| DOCKETED | |
|-------------------------|--|
| Project Title: | Commercial and Industrial Fans & Blowers |
| Document Title: | Ingersoll Rand presentation |

Considerations for Certain Embedded Fans

Response to Draft Staff Report, Analysis of Efficiency Standards and
Test Procedures for Commercial and Industrial Fans & Blowers
Docket Number 17-AAER-06

Product-level Impacts: Unitary Air Conditioner >760,000 Btu

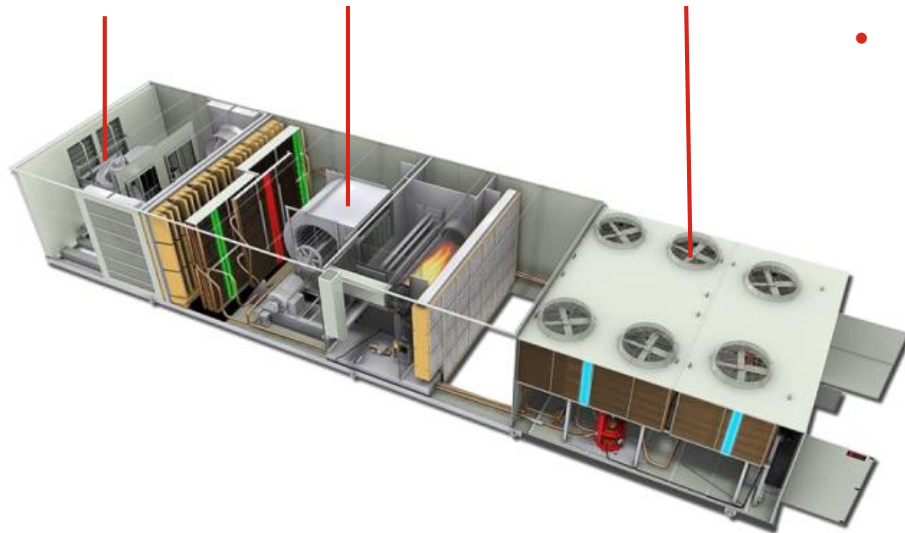
RELIEF FAN

3.6% of total energy consumption, not captured by IEER

SUPPLY FAN

5.1% of total energy consumption, captured by IEER

CONDENSER FANS

7.2% of total energy consumption, captured by IEER

- Theoretical maximum energy savings: 11,939 kWh/year*
- Retail product cost increase: \$17,200**

*Actual energy savings may be zero after product re-optimization.
